CITY OF FRANKLIN
PLAN COMMISSION MEETING*
FRANKLIN CITY HALL COUNCIL CHAMBERS
9229 W. LOOMIS ROAD, FRANKLIN, WISCONSIN
AGENDA
THURSDAY, MARCH 5, 2020, 7:00 P.M.

1. **PLANNED DEVELOPMENT DISTRICT NO. 37 (THE ROCK SPORTS COMPLEX/BALLPARK COMMONS) INDOOR SPORTS COMPLEX BUILDING AND SITE REVISIONS (BUILDING S3/C2).** Site Plan Amendment application (the subject building/Site Plan had been previously approved by Plan Commission Resolution 2018-007 on June 21, 2018, and amended by Resolution 2019-016 on September 19, 2019-construction has not commenced to date) by River Rock Performance Properties, LLC, applicant and BPC County Land, LLC, property owner, for (including but not limited to): removal of the office, retail, lobby and vestibule areas from the northeast corner of the first floor of the building [resulting in a reduced building footprint

REPORT TO THE PLAN COMMISSION

Project Name:	UW Credit Union Special Use and Site Plan Amendment
Project Address/Tax Key:	6611 South 27 th Street/714 0001 001
Property Owner:	Franklin Property & Fuel Services Holding LLC
Applicant:	UW Credit Union
Current Zoning:	Planned Development District No. 13
2025 Comprehensive Plan:	Commercial
Use of S

SHEET NUMBER:
A200

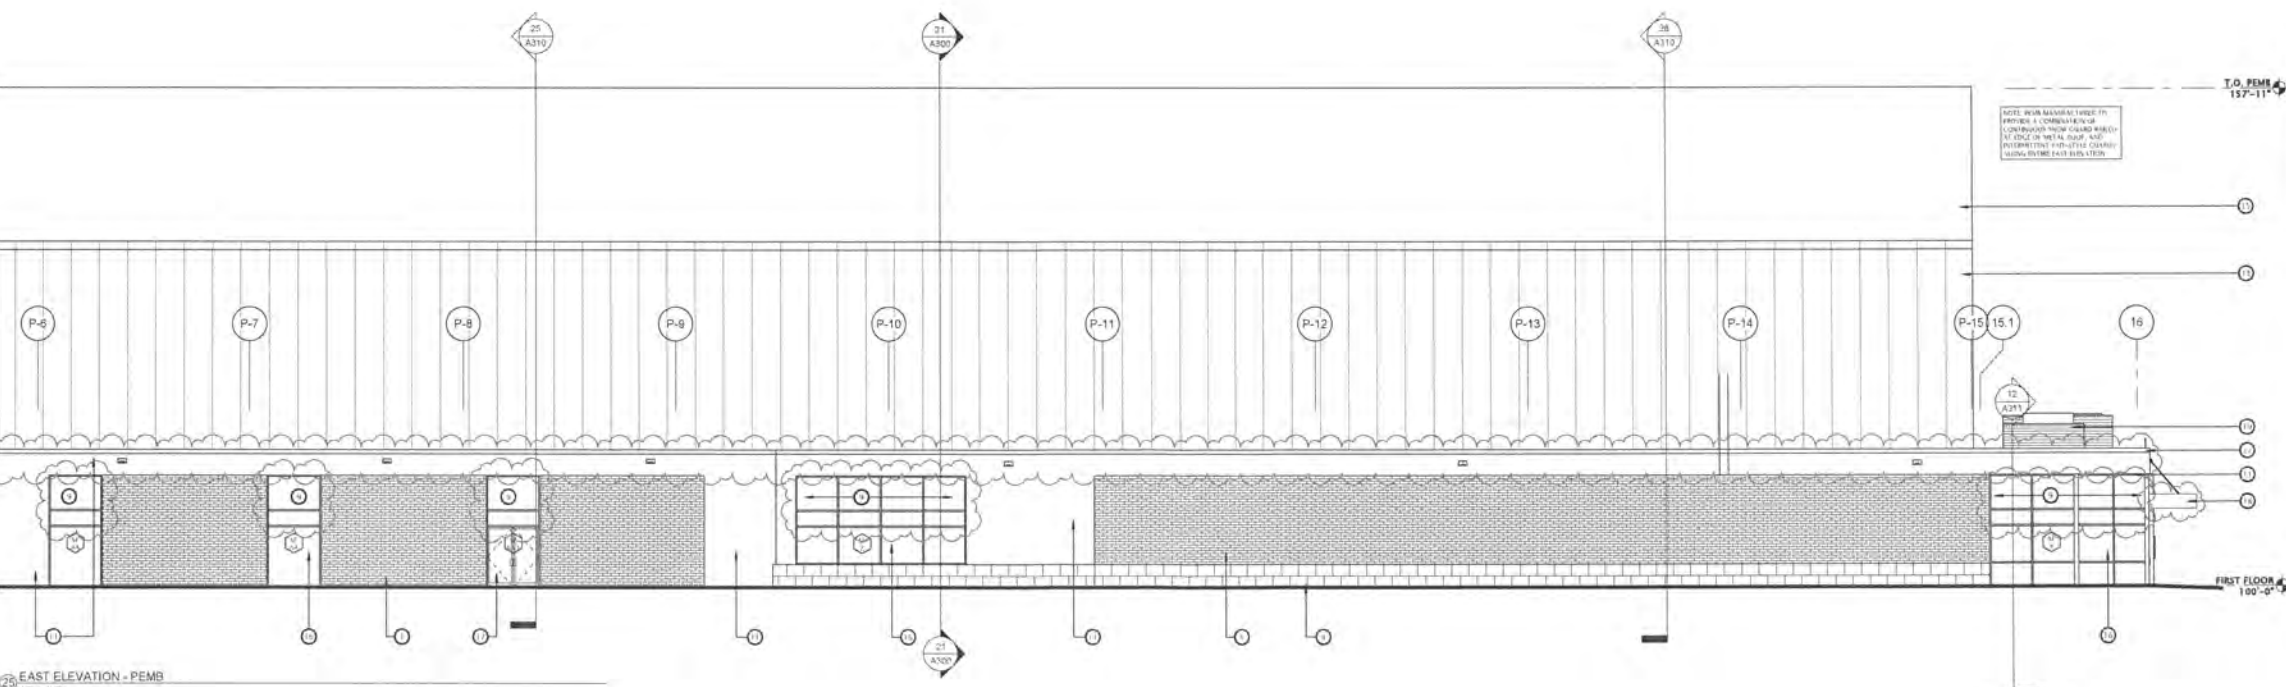
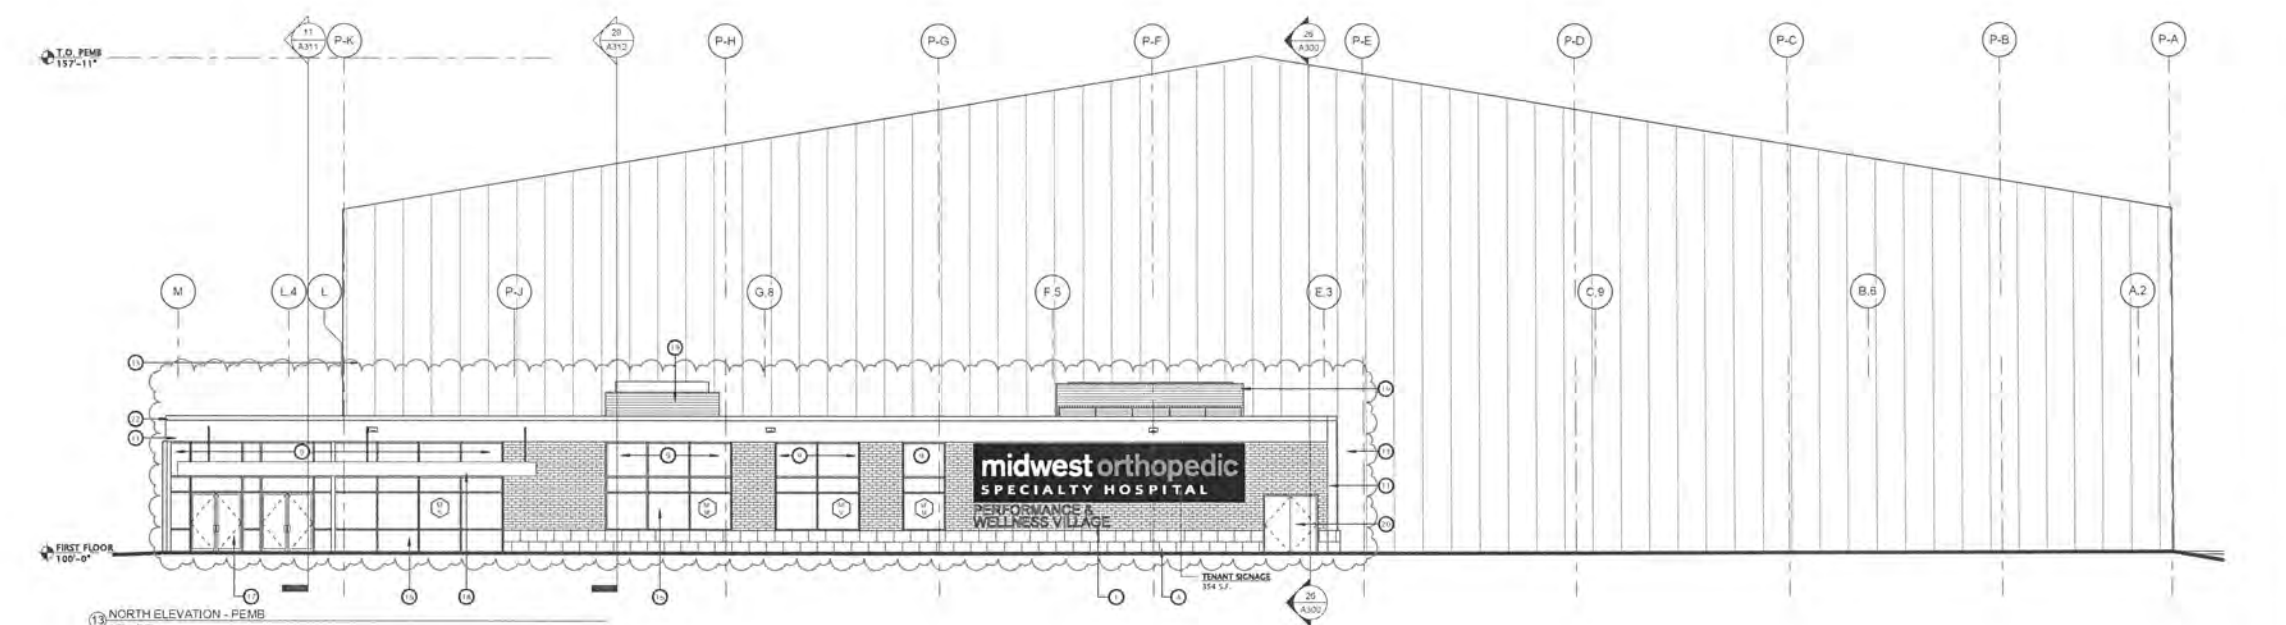
Per submitted plans, two entrances do not appear to comply with this requirement, specifically an entrance in the north elevation between P-K and P-J and another entrance in the east elevation located between P-10 and P-11 (see Sheet A200). Please add the two required architectural details to these entrances.

8. The proposed roof sign located in the south elevation between B.8 and N.2 (see sheet A200) does not appear to comply with the following requirements applicable to roof signs:
 - a. Municipal Code §210-4C(6)(a)(2): *An open space not less than four feet shall be maintained between the bottom of the sign or billboard facing and the roof, except that necessary supports extending through such space will be permitted.*

9. Per sheet A210 “Exterior images”, logos and signage would be located in the south elevation below the roof sign. It appears that these signs were not included in the signage schedule of sheet A200, please revise.

- a. north elevation between P-K and P-J
 - b. east elevation between P-10 and P-11
5. Architectural plans for the buildings trash enclosure can be found on sheet ASP-101. This sheet details the use of metal panels on enclosures exterior. The metal panels are the same style and color as those used on the adjacent field house structure.

9. The exterior images located on the south elevation below the roof sign were not included in the signage schedule on sheet A200 and have therefore been removed from the drawings, included is an updated rendering.

SHEET NUMBER
ASP-101

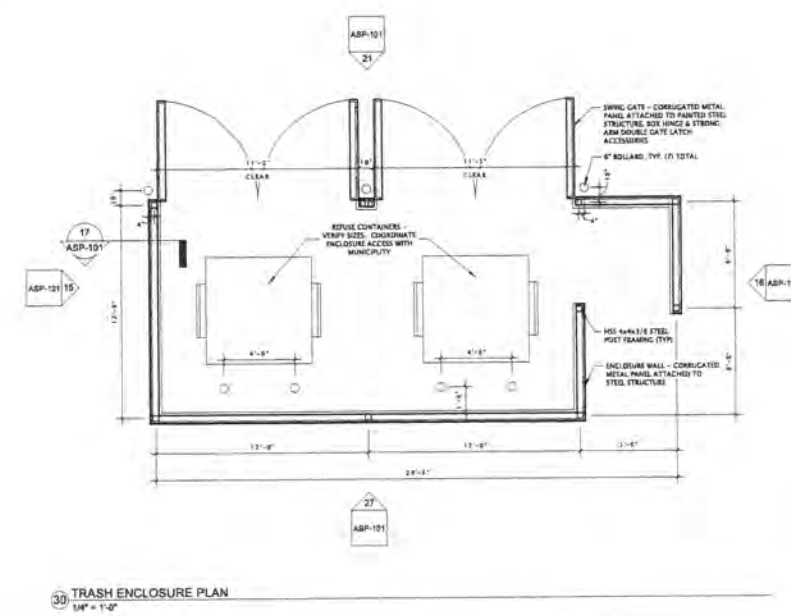
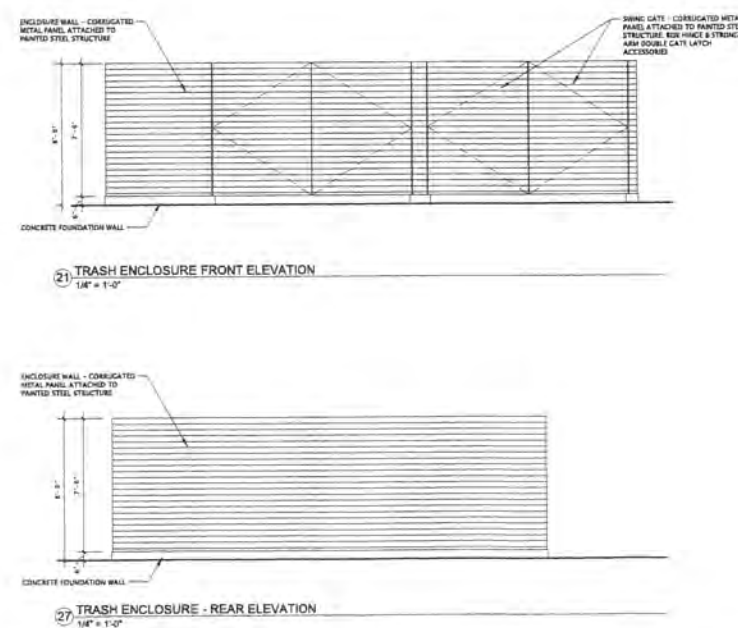
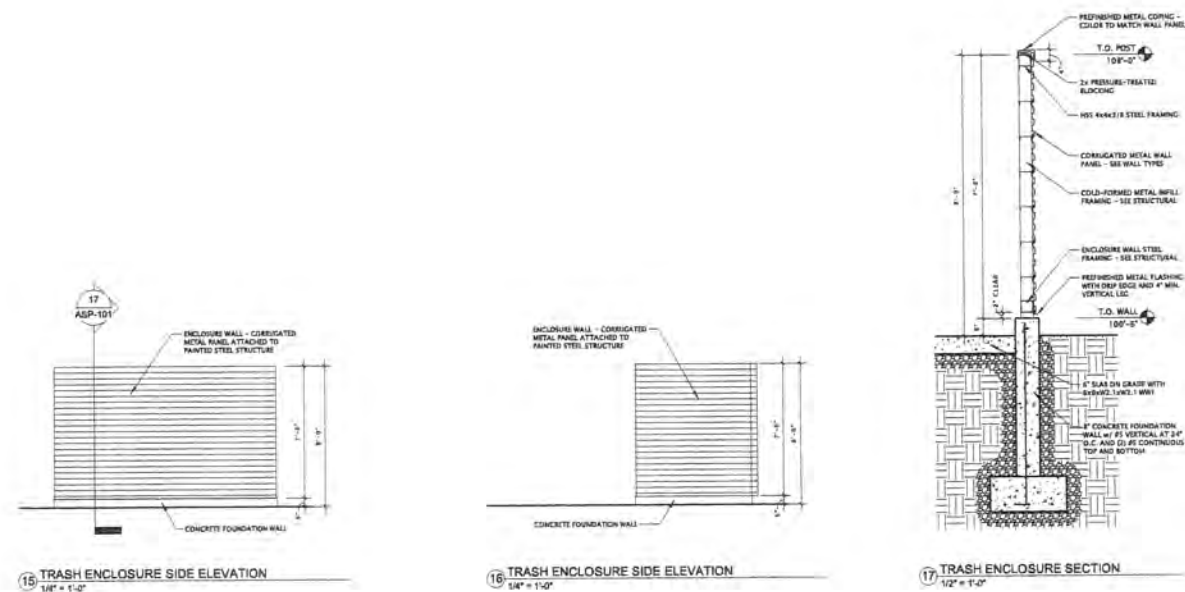
Per submitted site plan (sheet C2.1), note “H” refers to architectural plans for the trash enclosure located north of the principal building. However, the architectural plans have no details of the trash enclosure. Please provide details of the trash enclosure indicating compliance with the requirement cited above.
